SUBMITTAL COVERSHEET **Nanuet UFSD –Phase 3 Projects**

BMS WALLS SENSORS SHOP DWGS SIEMANS

THERMOSTAT LOCATION SUBMITTAL FOR
NANUET BOND PHASE3 HIGH SCHOOL

Job Name: Nanuet Bond Phase 3 High School
JOB #: 44OP-366733
Siemens Industry Inc – Smart Infrastructure
Thermostat location Submittal

SHEET NUMBER:
BM-M111

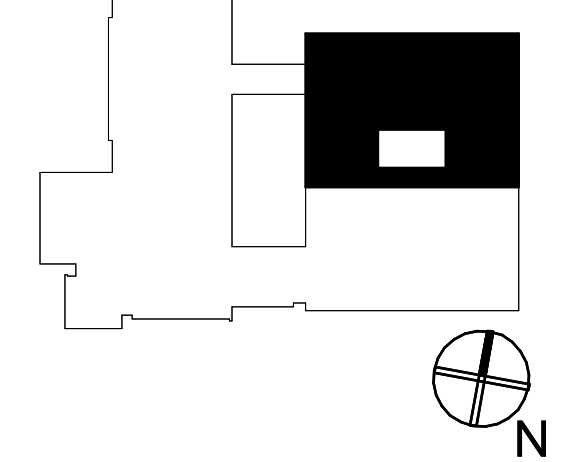
3. At the time of submission, as per DWG BM-M111, UV-MS-3 and FT-MS-1 serving classroom 102A are sharing a single thermostat. Siemens proposes a new BACnet thermostat which will be controlling the FTR valve. Space temperature reading from this thermostat will be shared with UV-MS-3. New separate thermostat is not considered for UV units.

BM-M112

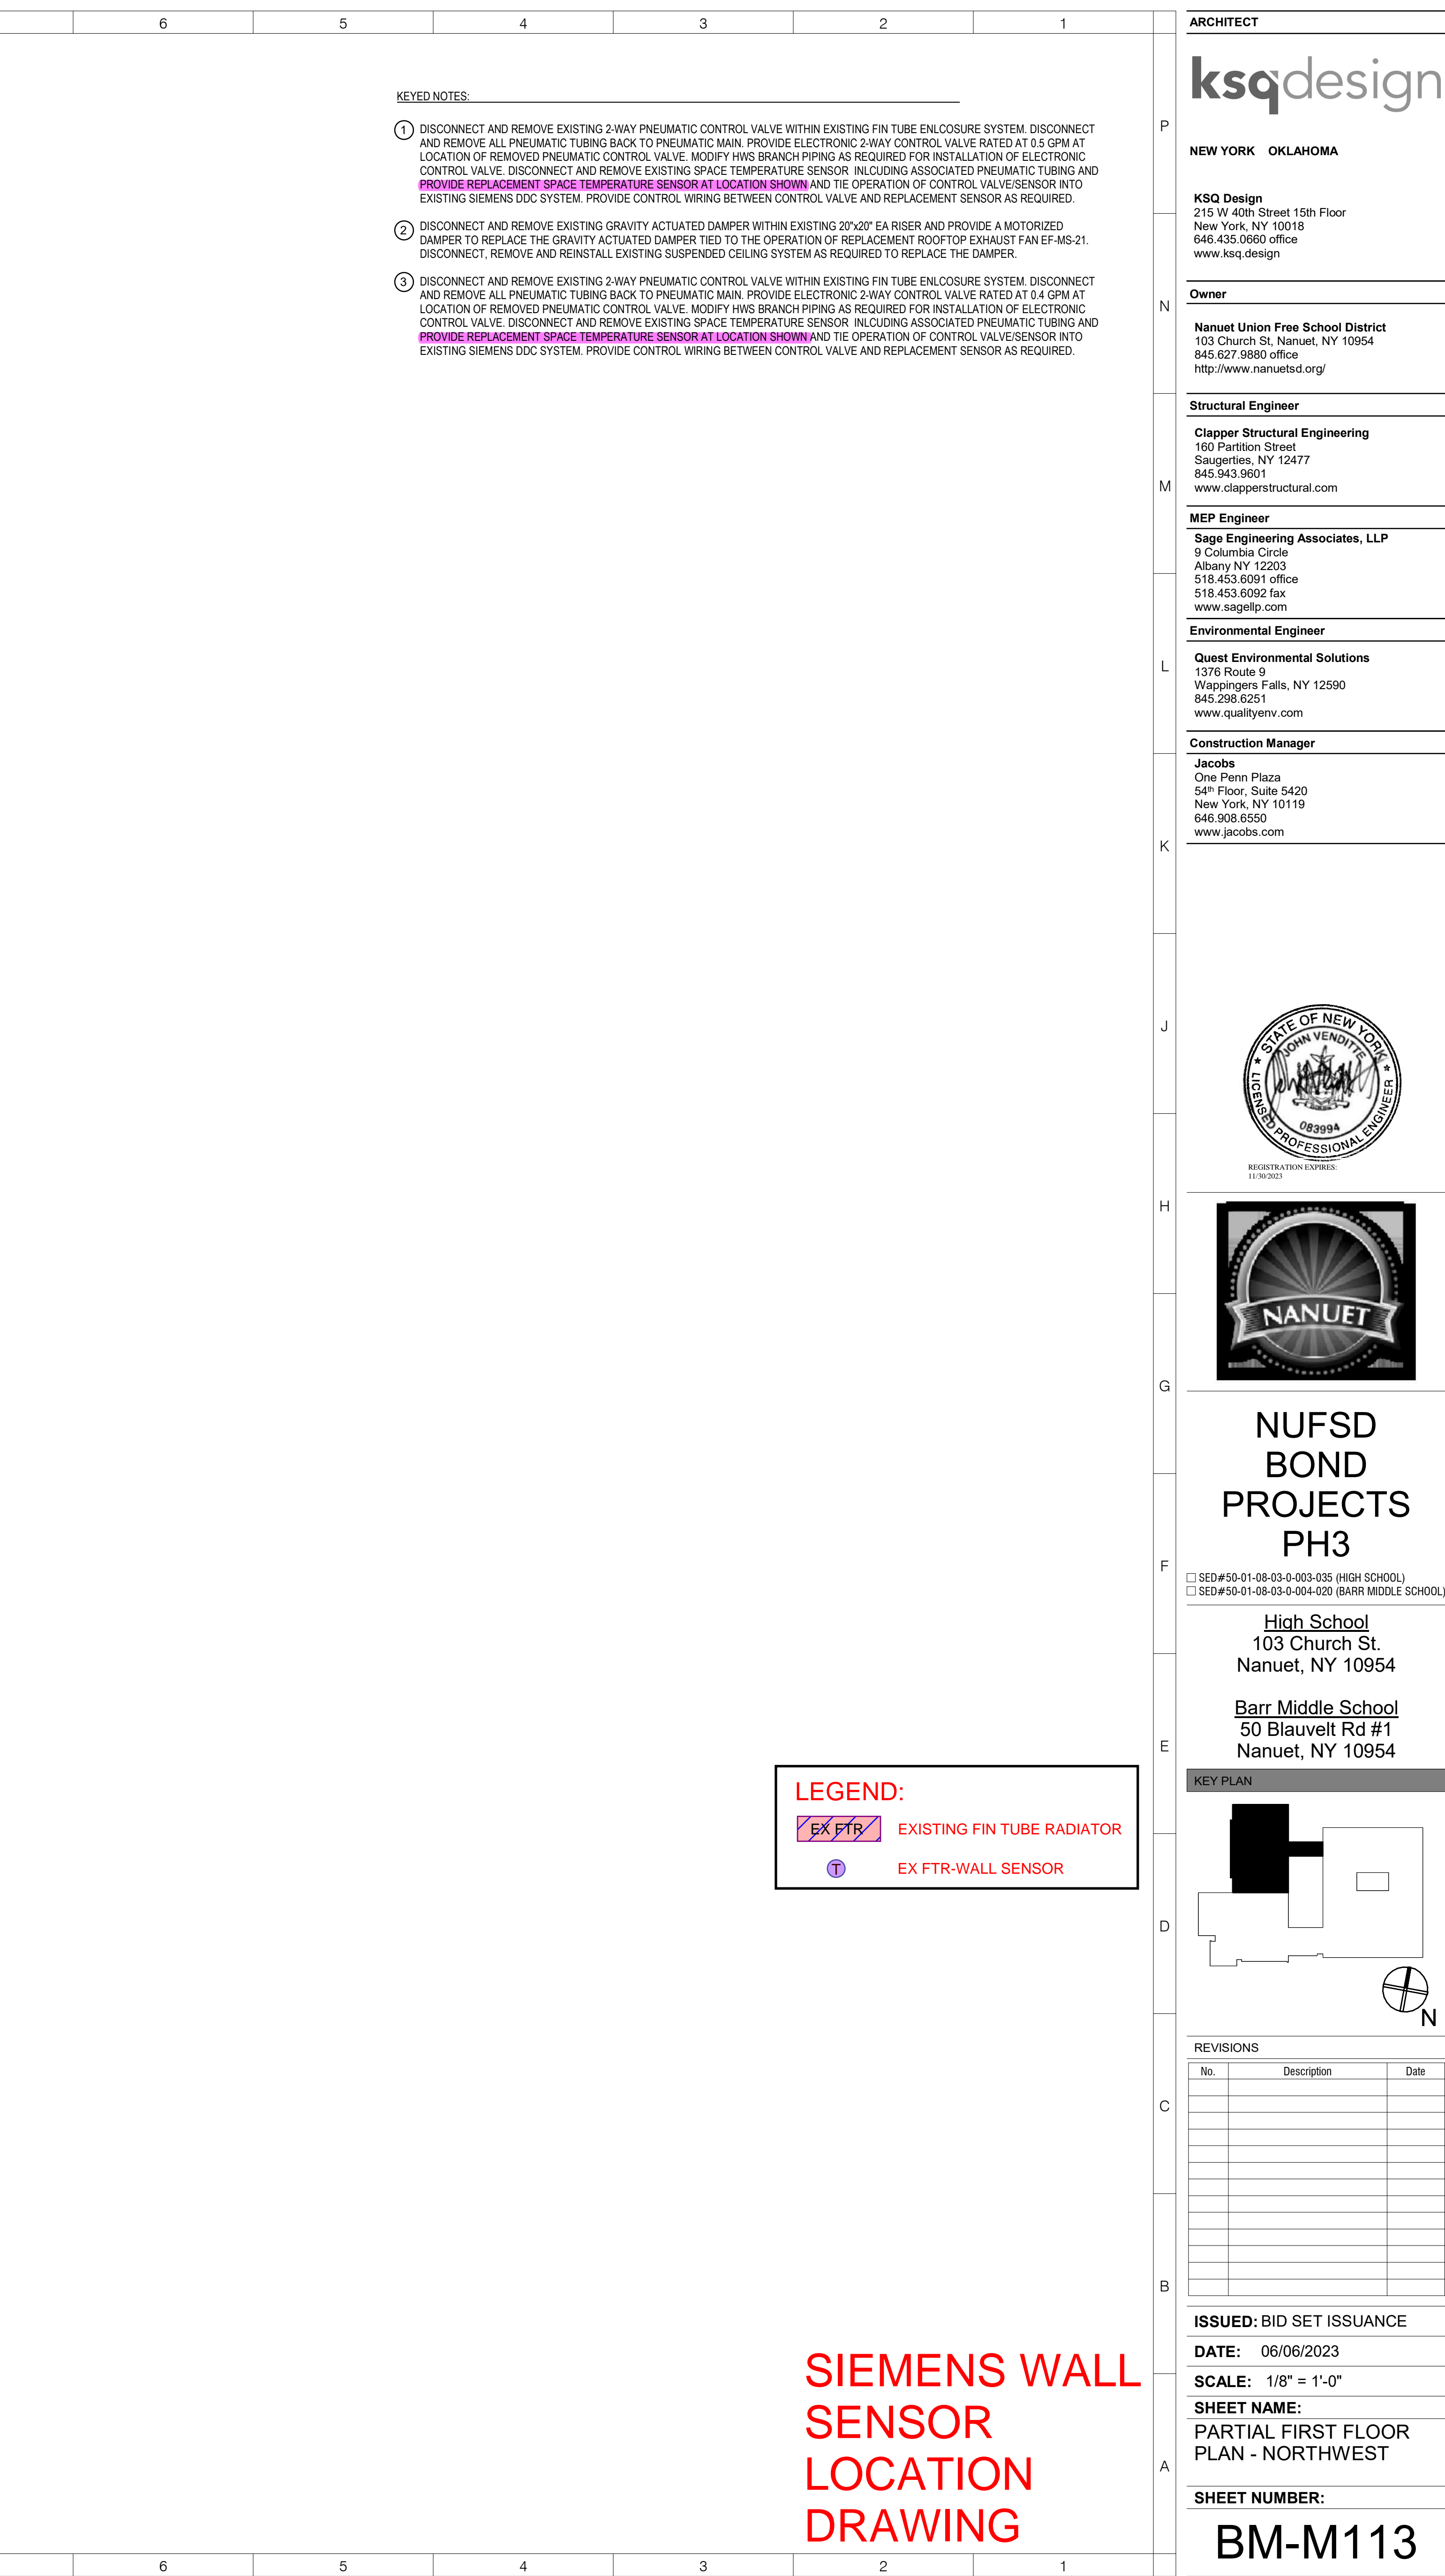
1. BACnet thermostats are proposed for controlling the existing & new FTR's, Heating Radiation & Convector Units.
2. At the time of submission, as per DWG BM-M112, note-4 thermostat is connected to EX S-2. However, as per note-28 the same thermostat is mentioned as it will be controlling the 2-way valve for EX FTR. Thereby new BACnet thermostat will be provided for EX FTR and temperature reading will be shared with EX S-2.
